**SUBDIVISION &  
SIDEWALK WAIVER STAFF REPORT****Date: June 5, 2014****NAME**

Belt Line Plaza West Subdivision

**LOCATION**1554 & 1558 West I-65 Service Road South  
(West side of I-65 Service Road South, 0.26± mile South of  
Cottage Hill Road)**CITY COUNCIL****DISTRICT**

# SITE PLAN

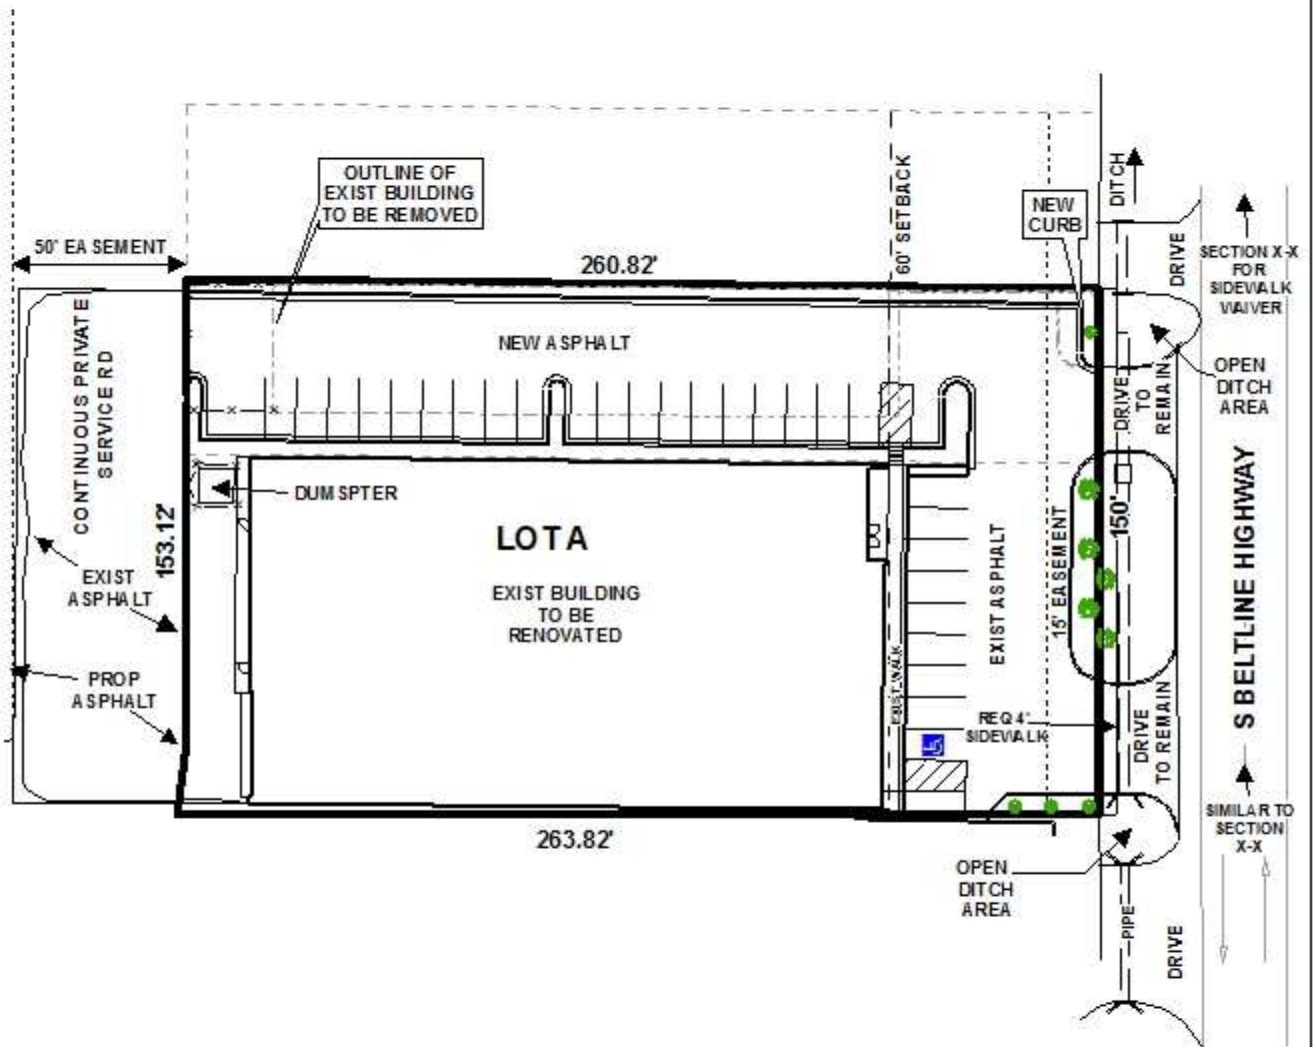
- A. Add a note to the SUBDIVISION PLAT stating that a Land Disturbance permit will be required for any land disturbing activity in accordance with the of the Storm Water Management and Flood Control Ordinance (Mobile City Code, Chapter 17 , Ordinance #65-007 & #65-045), latest edition. Storm water detention may be required for any future addition(s) and/or land disturbing activity.

- B. Add a note to the SUBDIVISION PLAT stating that as shown on the 1984 aerial photo (FLIGHT 24 - # 81) the Lot will receive historical credit of impervious area towards storm water detention requirement per the Storm Water Management and Flood Control Ordinance (Mobile City Code, Chapter 17, Ordinance #65-007 & #65-045), latest edition. Coordinate with City Engineering Department staff to establish the exact amount prior to the submittal of the Land Disturbance Permit application.

- C. Add a note to the Plat stating that the approval of all applicable federal, state, and local agencies (including all storm water runoff, wetland and floodplain requirements) will be required prior to the issuance of a Land Disturbance permit.

- D. Add a signature block for the Owner and Notary Public.
- E. Provide the Surveyor's, Owner's (notarized), Planning Commission, and Traffic Engineering signatures.

- F. Remove the County Engineer's signature block from the Plat. The County Engineer no longer signs plats within the municipal limits of the City of Mobile.

As on the preliminary plat, the Final Plat should retain the 60' minimum building setback line. The lot is labeled with its size on the preliminary plat in square feet and acres and should also be so-labeled on the Final Plat, or a table should be furnished on the Final Plat providing the same information.

As submitted, the plat contains a note and signature block for County Engineering. County Engineering no longer signs Subdivision plats where the subject property is fully within the City limits of Mobile; therefore, this note and signature block should be removed from the Final Plat.

- 1) placement of a note on the Final Plat stating that the Subdivision is limited to a maximum of two curb cuts, with the size, design and location to be approved by Traffic Engineering and ALDOT and in conformance with AASHTO standards.

- 2) retention of the 60' minimum building setback line on the Final Plat;
- 3) retention of the labeling of the lot with its size in square feet and acres, or the furnishing of a table on the Final Plat providing the same information.

- 4) removal of the County Engineering note and signature block from the Final Plat;
- 5) placement of a note on the Final Plat stating that development of the site must be undertaken in compliance with all local, state and Federal regulations regarding endangered, threatened or otherwise protected species;

# DETAIL SITE PLAN

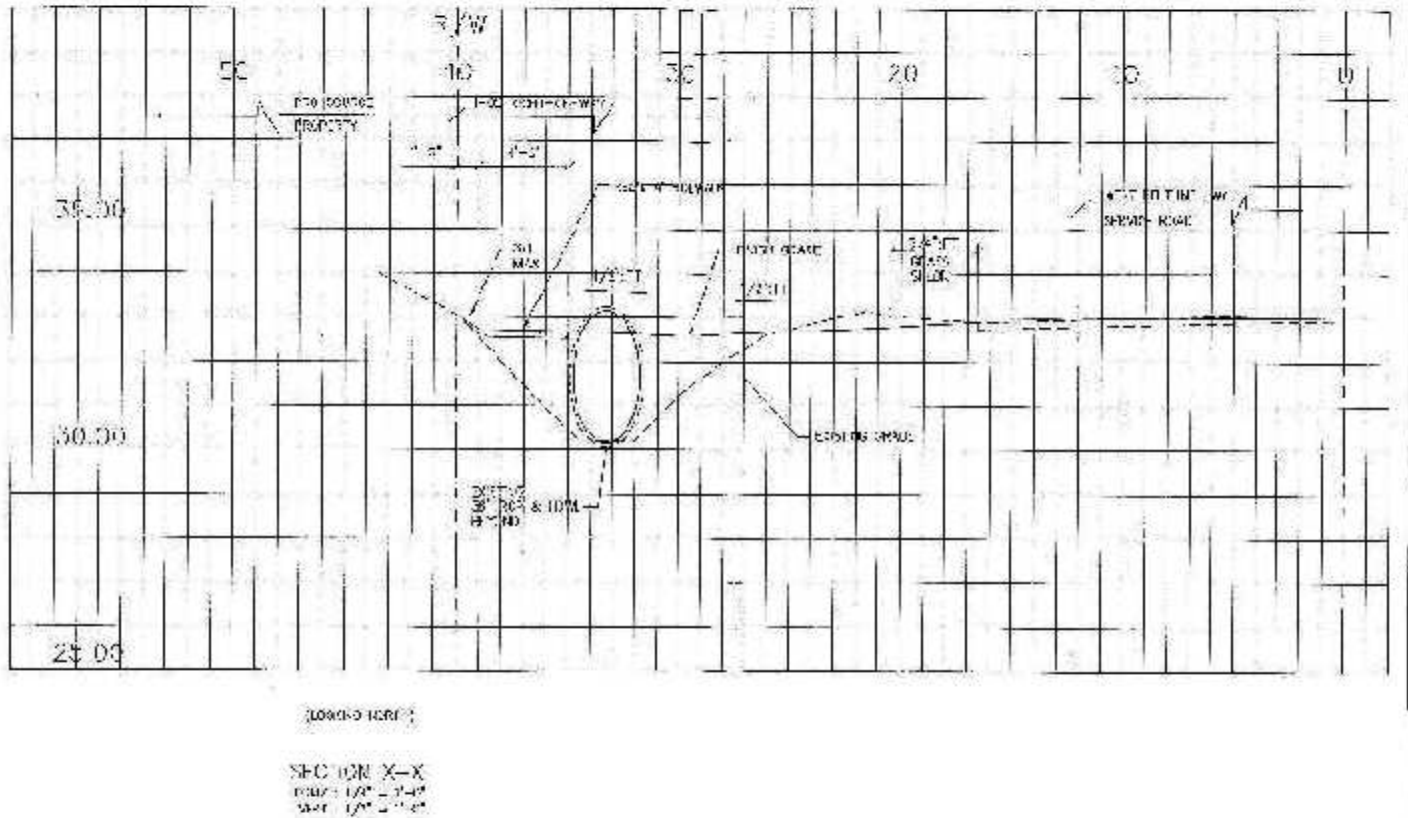
**Sidewalk Waiver:** Due to the location and size of the existing roadside drainage ditch on the I-65 Service Road it is recommended that this request be approved.

**Sidewalk Waiver:** Installation of a sidewalk will have a negative impact on the existing trees and tree roots along West I-65 Service Road South.

Regarding the Sidewalk Waiver request, the applicant states "Construction of a sidewalk is not feasible at the subject project due to existing open ditch areas (approx. 20 lf each) located at north and south end of property. These ditches are part of a drainage system that serves a majority of the property located along the service road. Between the aforementioned ditch areas is an existing 36" RC pipe. In order to construct a sidewalk these ditches would require piping and inlets. However, existing conditions and topography will not accommodate this due to the top of pipe elevation being approx. 6" higher than the centerline of the adjacent service road. A new sidewalk would require a major re-design of the current storm drain system with construction affecting the adjacent property owners. And, because this is ALDOT right-of-way their involvement would be mandatory."

City Engineering has determined that due to the size and location of the existing ditch, the request should be approved. One of the conditions of approval of the Parking Ratio Variance is the retention of the existing frontage trees. As Urban Forestry has determined that the installation of a sidewalk will have a negative impact on the existing trees and tree roots along West I-65 Service Road South, and as City Engineering has recommended approval, the approval of the Sidewalk Waiver request would be justified.

**Sidewalk Waiver:** Based upon the preceding, this application is recommended for approval.
